SUBJECT: Accept the Low Bid and Award the Contract for the Construction of Grand Avenue Resurfacing and Widening Project, Community of Lakeland Village. 1st District; [\$4,523,019]; Local Funds 100%

Project Number: C4-0074

MODIFICATIONS / CLARIFICATIONS TO PLANS

DESIGNED BY	CONSTRUCTION DETAILS	SHEET No.
APPROVED BY: <i>Michael O. Mueting</i> MICHAEL O. MUETING PROJECT MANAGER COUNTY OF RIVERSIDE DATE: 1-29-15	GRAND AVE RESURFACING & WIDENING STA 155+00 TO 159+00	C-2 SHEET 14 of 24

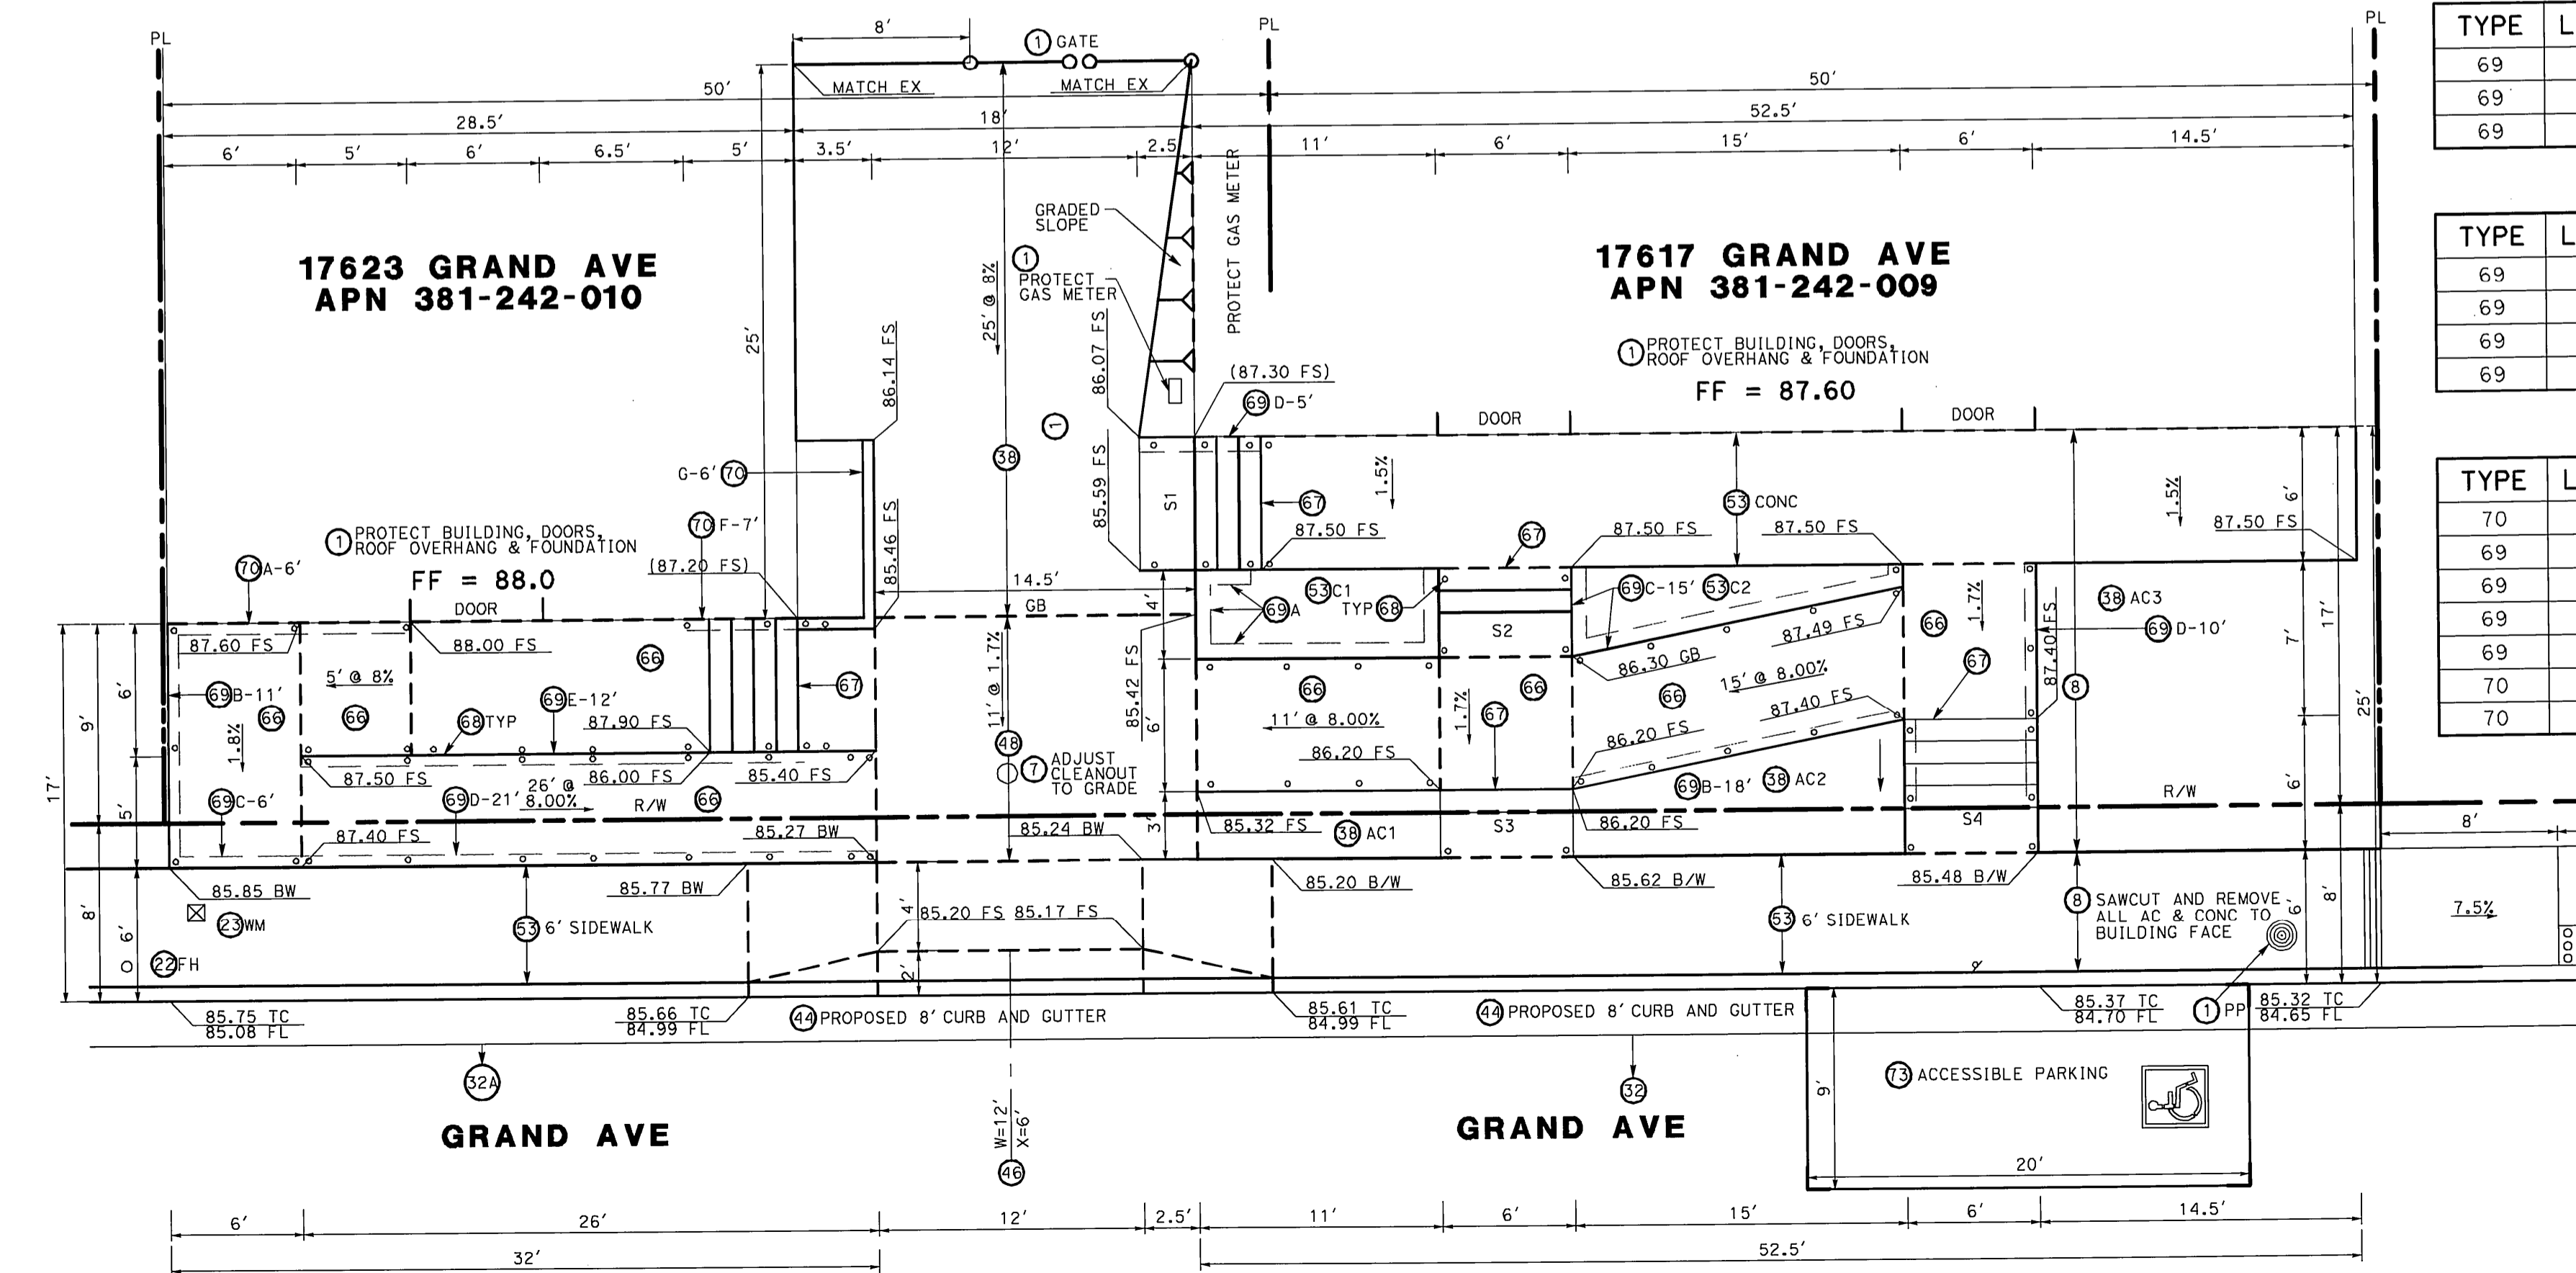
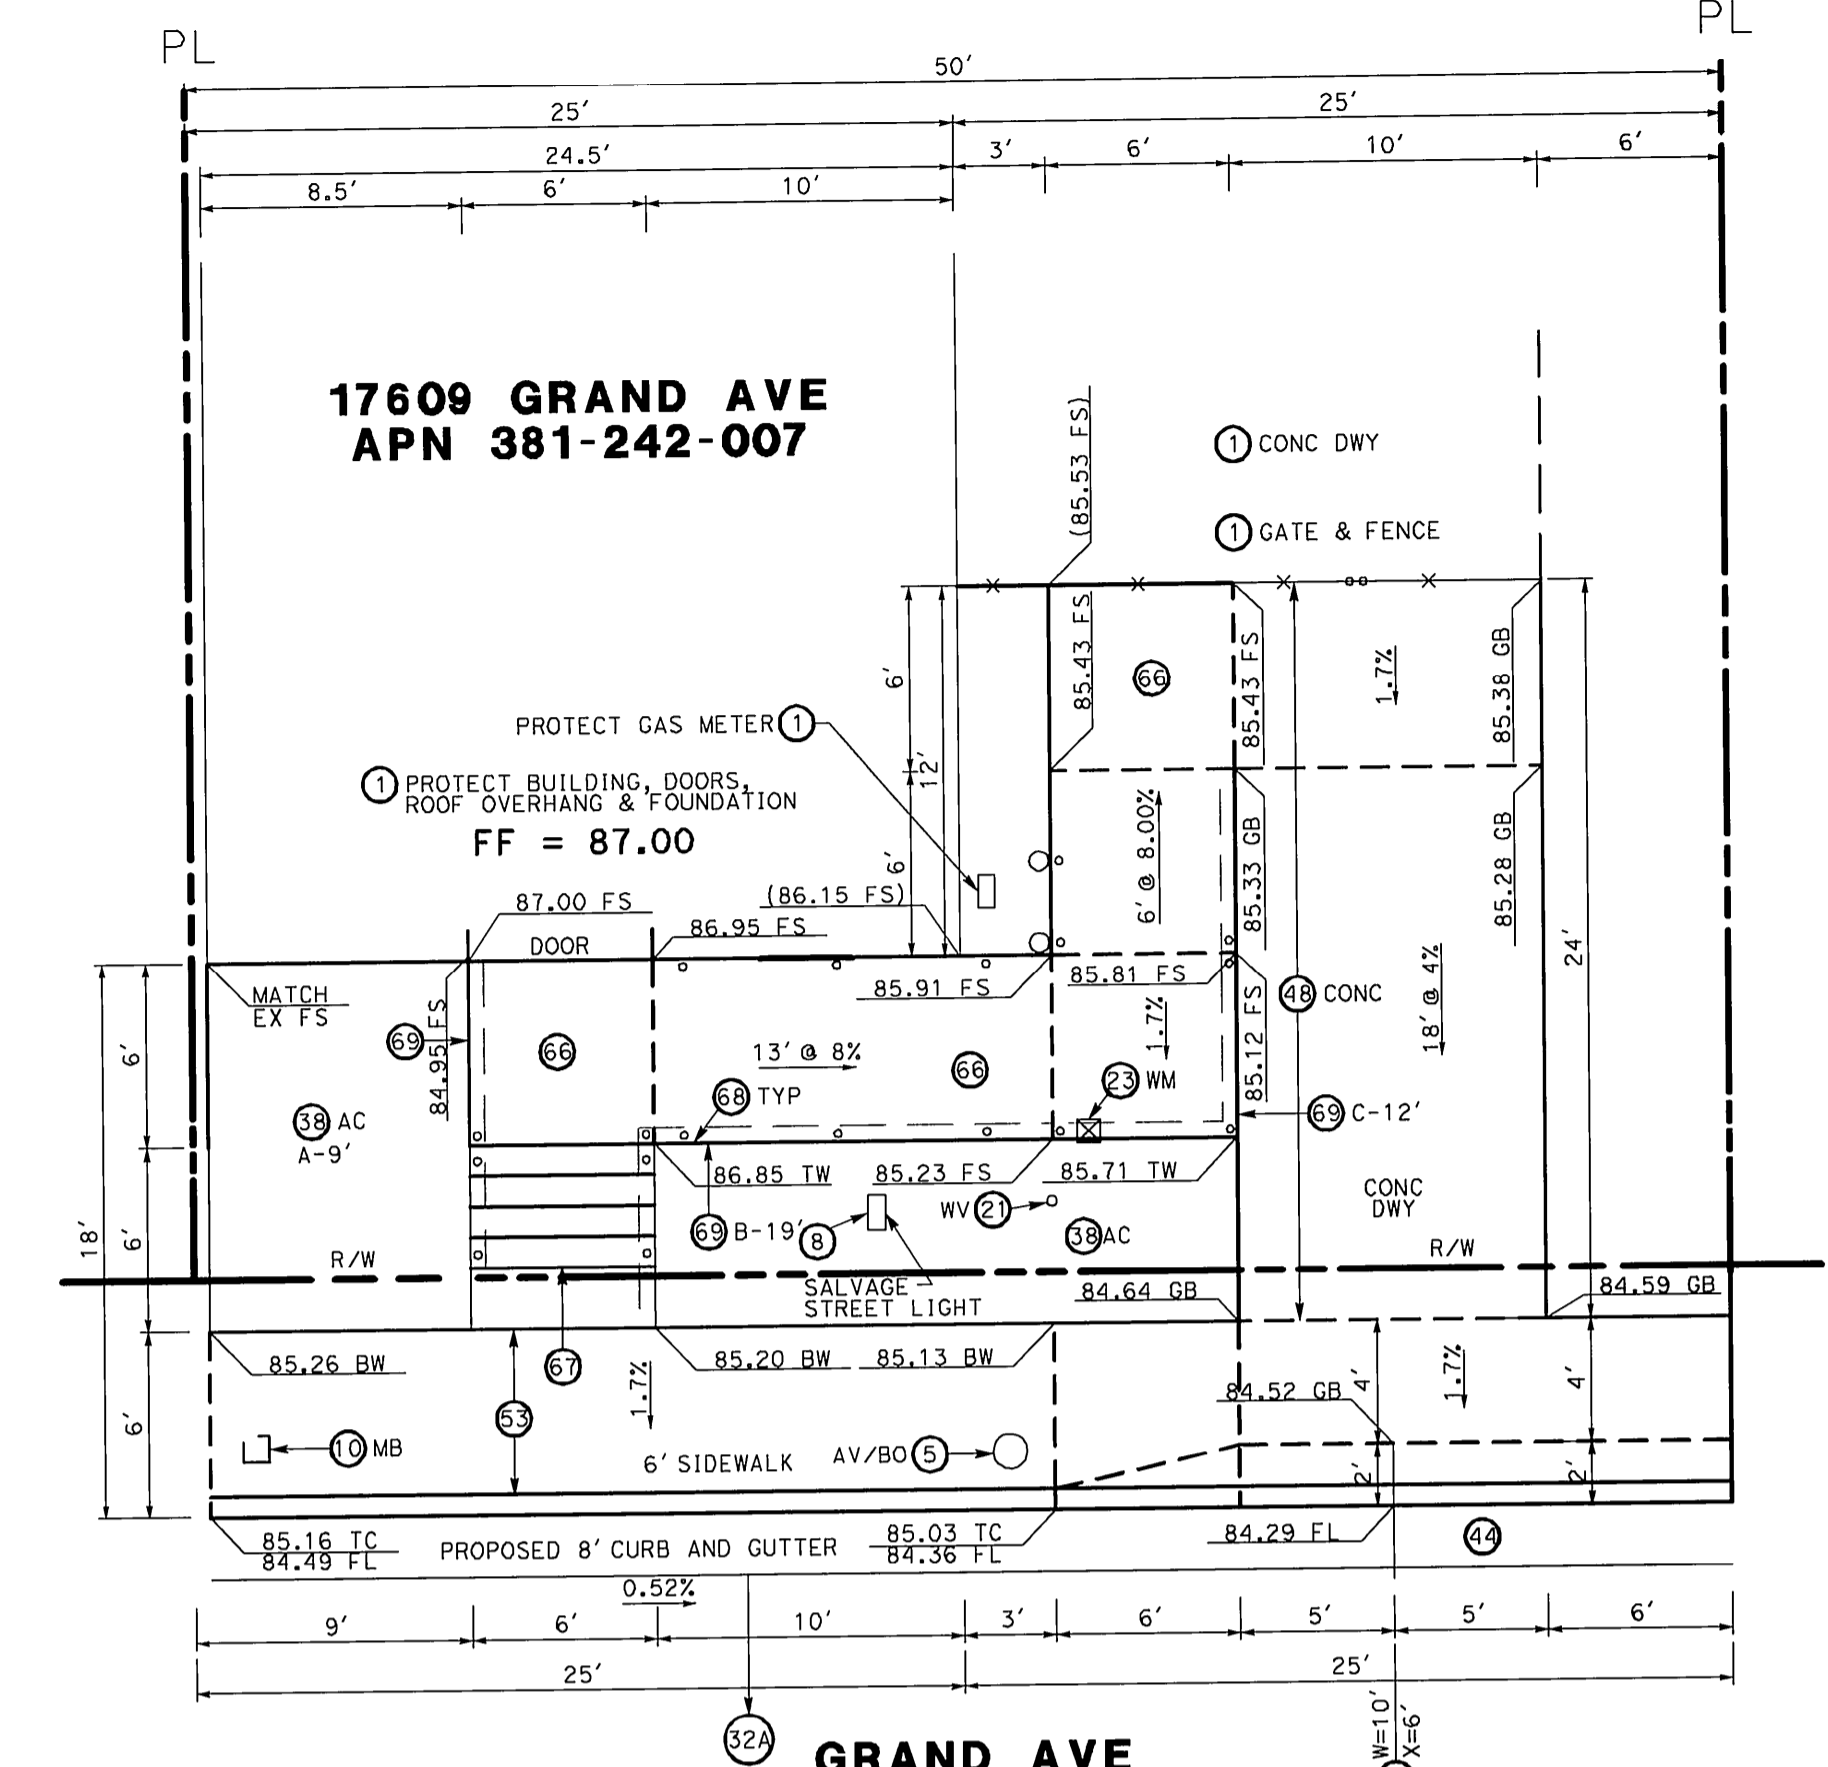
3. **Plan sheet C-2 (14 of 24)**

- Approximate Location of sewer laterals and underground utilities are added
- Construction Note 60 is revised to include "Two Grates-Perpendicular to the flow of Traffic"
- Construction Note 32 is deleted and 32A is added
- Construction Note 37 is deleted
